**Further Information Response for
Reg. Ref. SD22A/0039**

**Development at Silveracre Bungalow,
Whitechurch Road,
Rathfarnham, Dublin 14, D14 W2K8**

On behalf of
Dungrey Limited

August 2022

Figure 3 - Drawing no. D-0122-RFI-HTA-B-300 - Revised Design

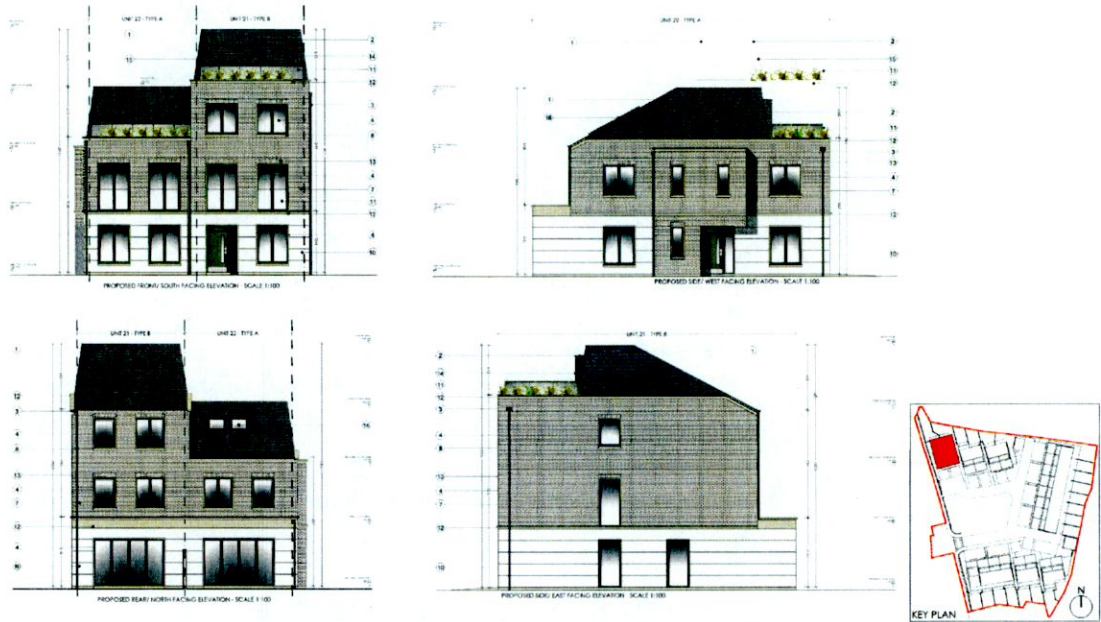
(a) A reduction in the height of the proposed dwellings to a maximum of 3 storeys;

This design change has been achieved by setting back the previously vertical roof line from the gable face of the buildings and applying a 9-degree angle to the roof walls. The same angle was also applied to the area of the roof which faces the front of the houses.

The glazed patio doors/ windows which provided access to the private amenity space at this level have been removed, the one access door that remains will be cladded in the same material as the proposed roof finish in such a way that it blends with the overall roof surface.

Figure 5 - Proposed Elevations Terrace units 21 to 22. Showing west facing elevation of unit 22 taken from Drawing no. D-0122-RFI-HTA-B-300 prepared by BBA architecture.

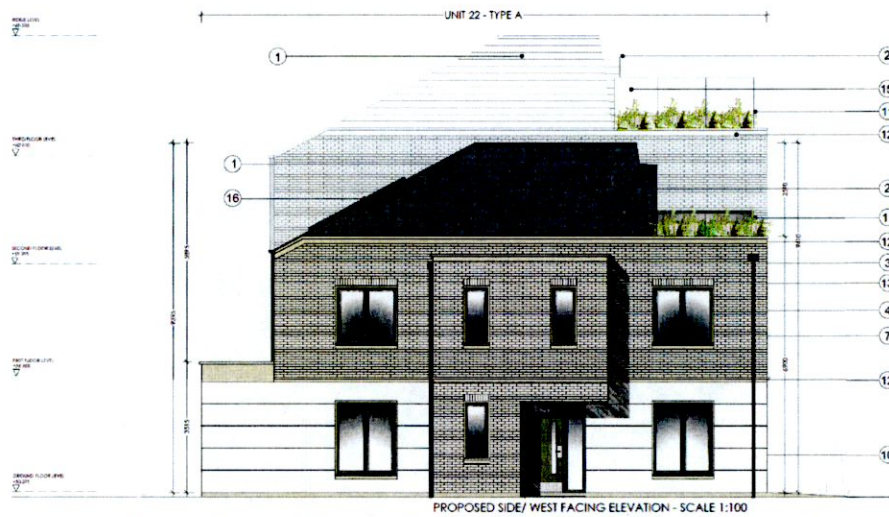
(b) Reconfiguration of Unit No. 1 and No. 22 to provide a frontage/ entrance onto Whitechurch Road. The proposed boundary treatment along this boundary should be revised to provide a privacy strip behind a low wall, hedge, or railings until where it meets the rear private amenity space behind the dwellings along this boundary.

- The front entrance to both dwellings has been moved to the western facing elevations facing Whitechurch Road, providing these units with appropriate dual frontage and improving the framing and interface between Whitechurch Road and the proposed development. Please refer to the elevations in the figures below and BBA drawing Nos. D-0122-RFI-HTA-A1-A2-201, D-0122-RFI-HTA-A1-A2-300, D-0122-RFI-HTA-200, D-0122-RFI-HTA-300 and D-122-PL-SS-500 for further details.

Figure 10 – Section of Site Layout showing unit no. 8 and its private open space taken from BBA drawing no. D-122-RFI-SL-104.

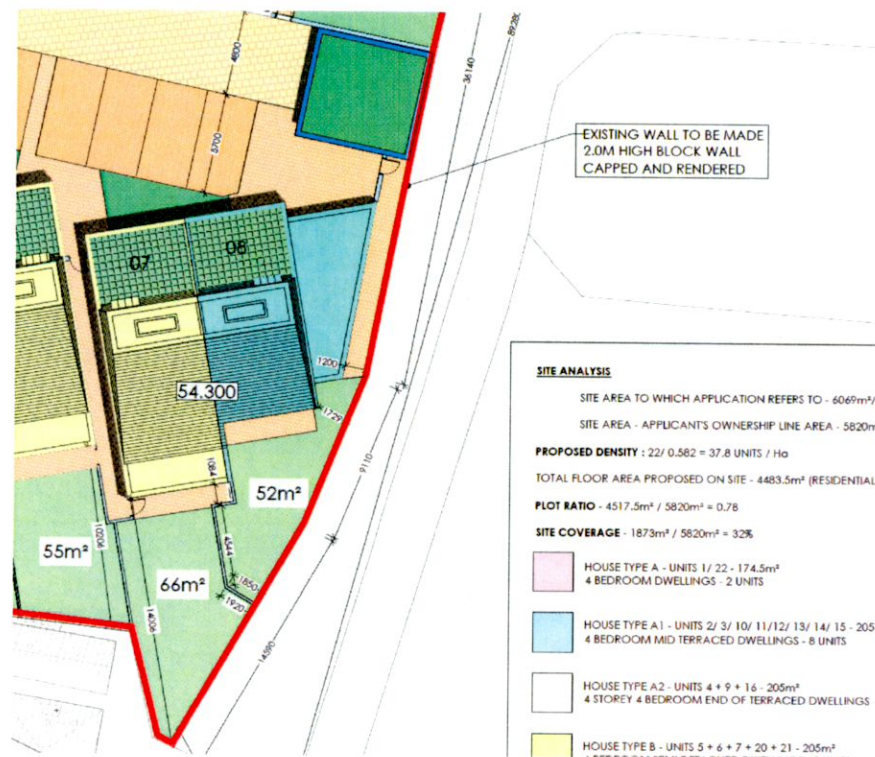
House No. 8's private garden space wraps around the rear and side, and to the front, of the dwelling. The CDP states that private open space should be located behind the front building line of the house and be designed to provide for adequate private amenity. It would also be preferable that this space was more combined for usability. The applicant is requested to submit a revised layout for House No. 8 so that a more combined area of private amenity space is provided behind the front building line of the dwelling.

Both unit 8 and its associated private open space in the garden have been redesigned and adjusted to improve adequate private amenity space to the rear of the dwelling. The overall depth/footprint of the dwelling has been reduced by approximately 1.4m and compensated by redesigning the eastern element of the dwelling. This allows for an extra 1.4m depth and approximately 8m² of private amenity space in this area to give a total of 52sqm at ground floor level, in addition to the roof terrace. The location of the rear garden fences separating units 7 and 8 have also been adjusted to create a higher quality, more usable private amenity space.

We note Table 11.20 of the South Dublin County Development Plan requires a minimum of 70sqm for private open space for 4-bed units. Unit no. 8 provides 72sqm of private open space and is therefore in line with Development Plan standards.

Please refer to BBA drawing no. D-122-RFI-SL-104 for further details. We trust this design revision is sufficient to address the requirements of Further Information item 2.

Figure 11 – Location of the Surface Water Pipe within strip of land
Drawing No. PL-102-P2 prepared by POGA

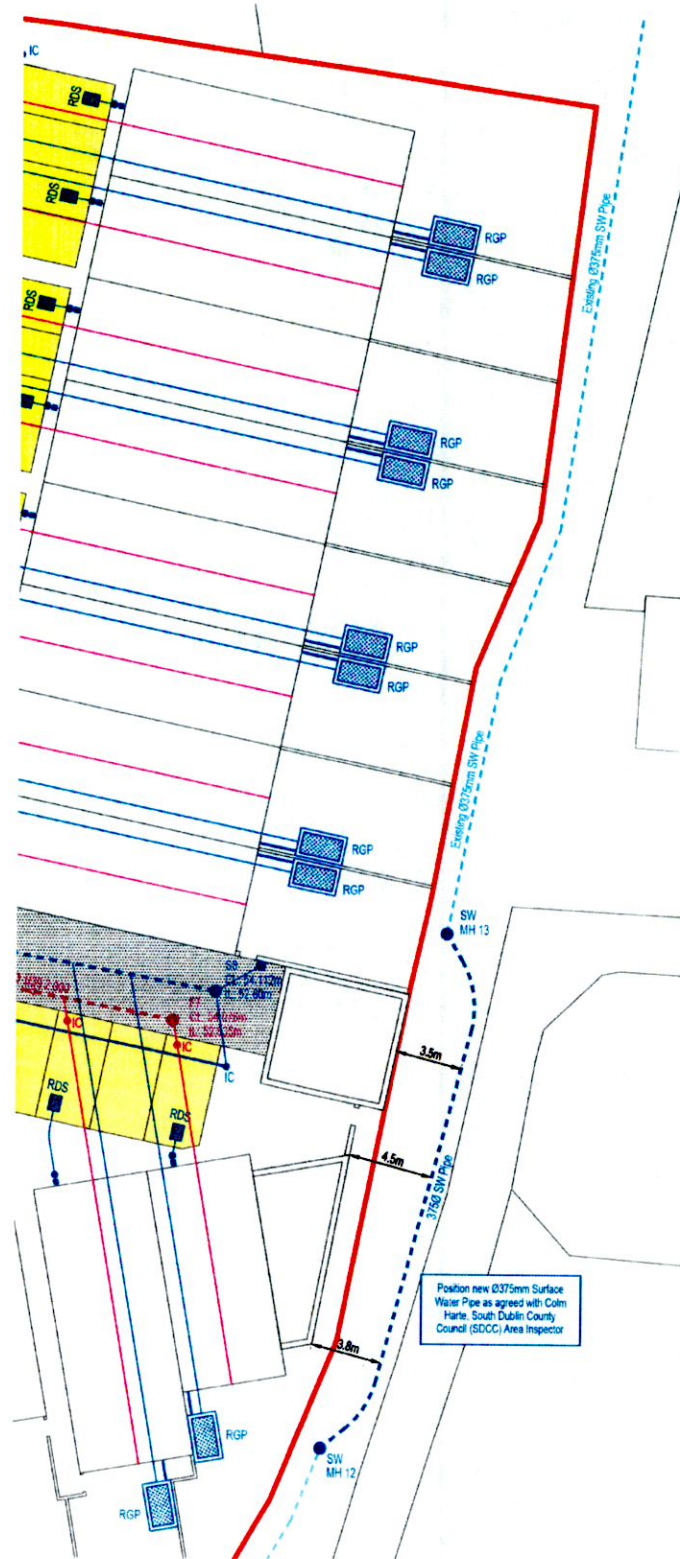
The Planning Authority is concerned that as a result of the proposed development the strip of land to the east with surface water infrastructure would be further isolated and access to it restricted (when required for maintenance). The applicant is requested to consider this strip of land (and the piped stream) in the overall development. It is requested that the nature of this infrastructure, whether it is only a piped stream, is confirmed. The site boundary (red line) should be extended to include this strip of land. The applicant should consider whether appropriate landscaping could be provided along this strip of land (in line with ecological surveys). Dedicated access to this strip of land from the subject site should be provided. An appropriate setback distance of structures from any pipe should be provided. The separation distance of the proposed bicycle store and House No. 8 in particular from the eastern boundary should be reviewed in relation to this.

In relation to the piped infrastructure through the strip of land, the position of the pipe was ascertained on site and a new position for a portion of the pipe was agreed with Mr. Colm Harte, South Dublin County Council Area Inspector. The position of the pipe ensures adequate setbacks with any proposed buildings within the scheme. We refer the Planning Authority to POGA Drawing PL-102-P2, which is illustrated below in extract and which provides details of the route of the pipe along this strip of land and setback distances achieved.

Figure 16 - Play area specification and equipment from Drawing No. 7260 L012 prepared by Park Hood Chartered Landscape Architects

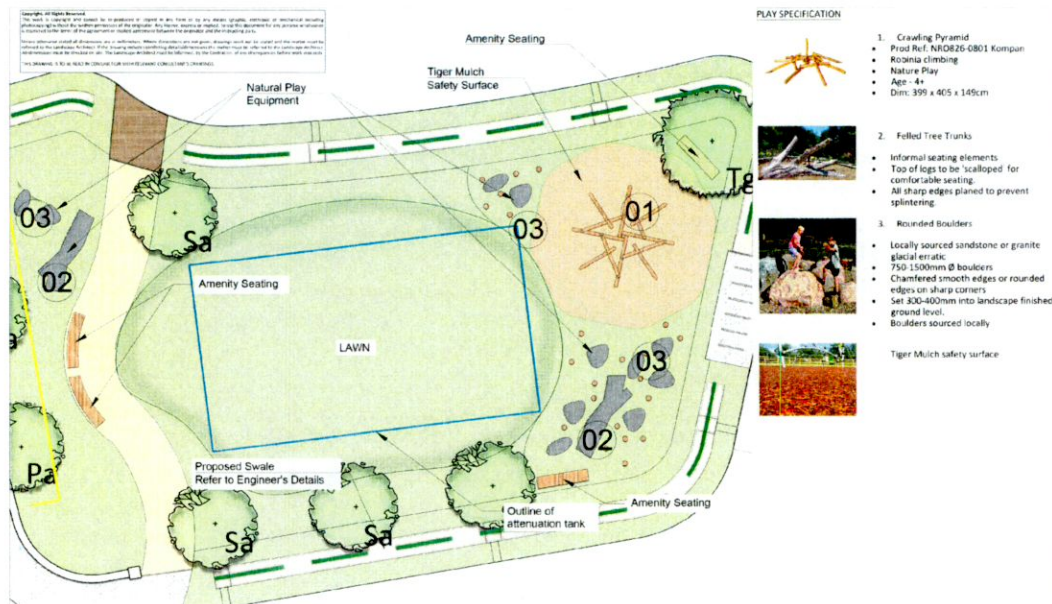
(d) A detailed play strategy for the subject site to be submitted, additional details to be provided include:

- A specification of all play equipment to be installed including provision for children with disabilities and special sensory needs;
- A specification of the surface treatment within the play areas; and arrangements for ensuring the safety and security of children using the play areas.

<p>4 (d)</p>	<p>A detailed play strategy for the subject site to be submitted, additional details to be provided include:-</p> <ul style="list-style-type: none"> • i. A specification of all play equipment to be installed including provision for children with disabilities and special sensory needs; • ii. A specification of the surface treatment within the play areas; and arrangements for ensuring the safety and security of children using the play areas. 	<p>Play facilities within a specified area have been added to the proposals as set out in Drawing No. 7260 L101 Landscape Proposals.</p> <p>Additional information in terms of specification and equipment are set out on Drawing No. 7260 L012 Play Area Specification</p>
<p>4 (e)</p>	<p>An Alien Invasive Plant Species Survey Report for the subject site.</p>	<p>An Invasive Species Assessment Report has been prepared by Enviroguide Consulting in July 2022 and forms part of the FI submission.</p>

The proposed layout of the play area and associated play equipment is shown below for illustrative purposes.

Figure 17 - Figure taken from Drawings no. 21029-105 illustrating section through attenuation Tank and Detention Basin prepared by POGA Consulting Engineers.

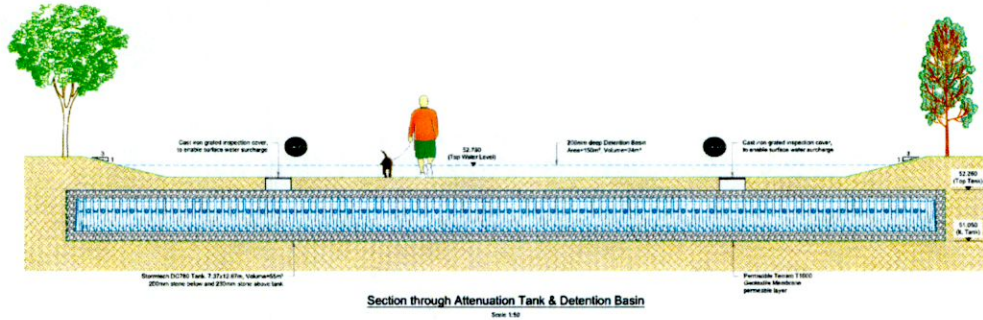
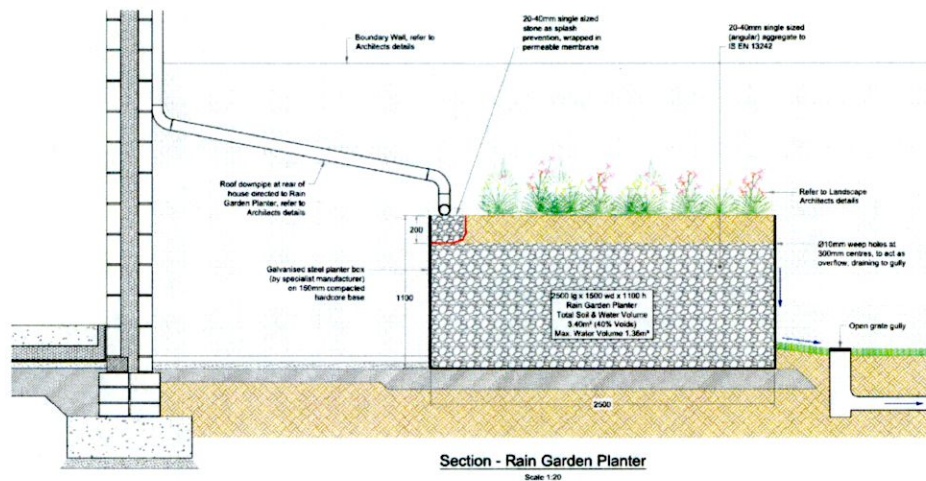
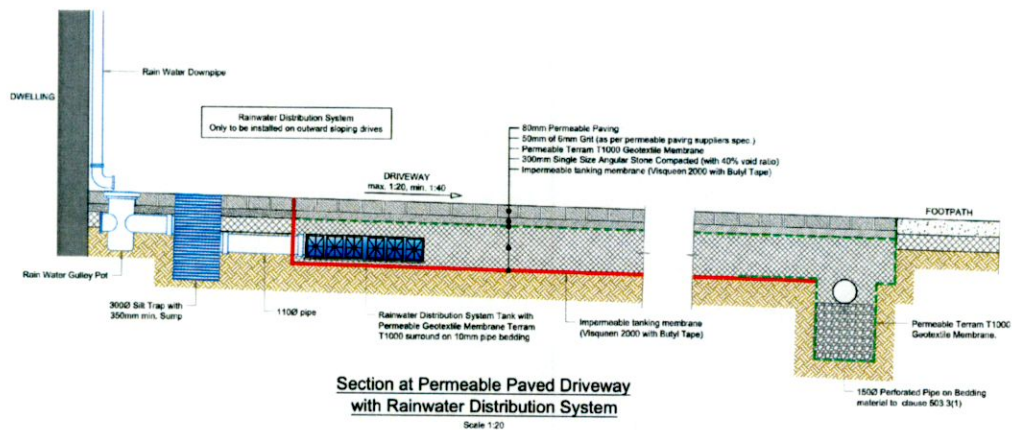
(a) The issue of surface water attenuation has been raised as a significant concern for the Public Realm Section. A revised proposal is requested that includes further provision of additional natural above ground SuDS features to reduce or remove the need for an attenuation tank within the development. Further consideration of the breakdown in provision of open space, the location and size of attenuation tank proposed, and the incorporation of additional SuDS measures needs to be carried out. The response should include revised layout and drawings and avoid the use of underground tanks within open space areas where possible. The applicant is referred to the recently published SDCC SuDS Design Guide for further information and guidance. Examples of above ground SuDS to consider include:

(b) The applicant is requested to submit a drawing and report to show what SuDS are proposed for the development. Show in m³ what surface water attenuation capacity proposed SuDS systems have.

POGA Consulting Engineers have consulted with Brian Harkin, Senior Executive Engineer at South Dublin County Council and agreed a surface water drainage philosophy. Additional SuDS features have been incorporated into the design of the scheme including;

- permeable paving at the driveways with infiltration trenches at the base,
- a raingarden planter at the rear of each dwelling to store and treat the run off from 50% of the roofs,
- swales and infiltration trenches to drain sections of the road, and
- a 200mm deep over ground detention basin to store the attenuated storm water flows generated by the 1 in 100 year storm event.

In addition the design team have reduced the size of the underground attenuation storage system. However it is not possible to remove the attenuation storage under public open space completely due to the 1 in 100 year storm event.

We refer the planning authority to Appendix A of POGA Consulting Engineers report which responds to item 5(b) in relation to the SuDs that are proposed. Appendix A shows a full break down of the SuDs treatment philosophy with the attenuation capacity provided for each system. Drawing no. 21029-102 and 105 display the attenuation storage capacity provided.

Figure 20 - Location of Subject site on RPS consulting engineers Dodder Catchment Flood Risk Assessment and Management Study Figure No. OSWS/EXT/UA/CURS/103

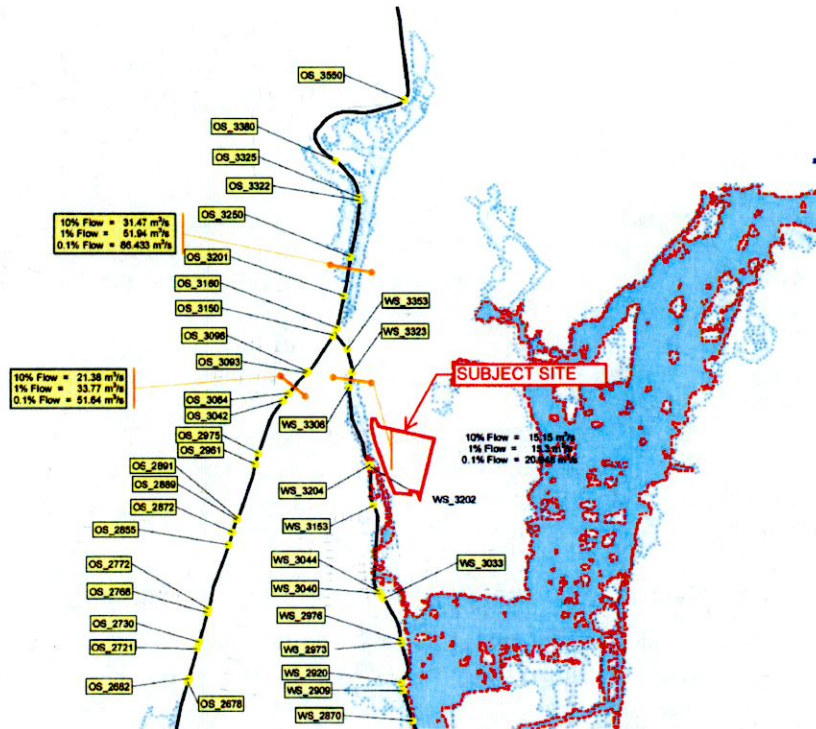
The applicant is requested to submit a report and drawing to clearly show the location of proposed site on an OPW CFRAM Flood map. This will identify the location of site relative to adjacent flood zones if any and determine if any flood risks arise. If there is a risk of flooding such as a 1 in 1,000 year flood risk outline in a report and drawing what flood mitigation measure are proposed for the development. Outline in report what if any flood risk there is for property upstream and downstream of proposed development due to same. Prior to the submission of revised documents, the applicant might contact water services of South Dublin County Council to discuss same.

We refer the planning authority to Appendix C and to the figure below of POGA Consulting Engineers report which shows the site boundary in red imposed on the RPS flood map.

RPS Consulting Engineers produced this map as part of the Dodder Catchment Flood Risk Assessment and Management Study. The map identifies areas of predicted flooding along the Owendoher and Whitechurch streams, water levels for the 10, 100 & 1,000 year storm events are provided at various node points. Node points WS-3202 & WS-3204 are located along the Whitechurch Stream directly across the street from the subject site, the highest recorded flood levels at these points are; 52.02m (1:100 year event) and 52.30m (1:1000 year event). The lowest finished floor level at the subject site, 53.275m, is 1.2m above the 1:100 event and over 975mm above the 1:1000 event.

The site and proposed development is therefore not at risk should a flood event occur.

Figure 21 – Uncontrolled pedestrian crossing on White Church Road Drawing No. 2021 C725.1_1 v1.6 Prepared by Transport Insights

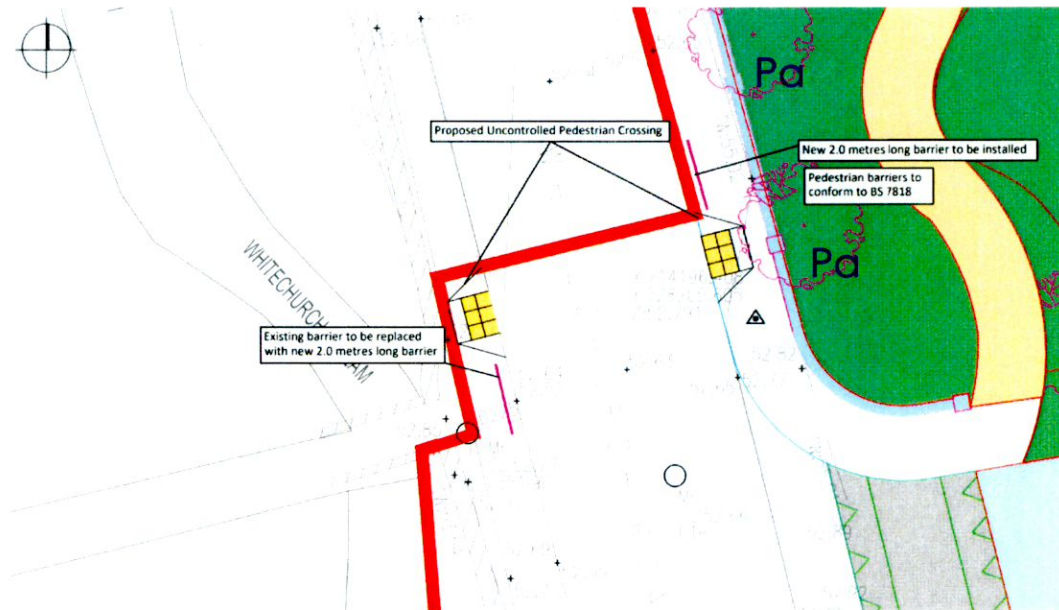
(b) A revised layout not less than 1:100 scale showing the location, design, and construction of an uncontrolled pedestrian crossing from the development to the footpath on the west side of Whitechurch Road, including safety barriers. To be constructed by the applicant/developer and at their own expense.

We refer the planning authority to Section 3 and Appendix B of Transport Insights report where details of the uncontrolled pedestrian crossing has been prepared. The proposed uncontrolled pedestrian crossing is located at the pedestrian access to Willbrook Grove in order to better accommodate pedestrian movements and desire lines at this location. A drawing of the uncontrolled pedestrian crossing is illustrated in the figure below.
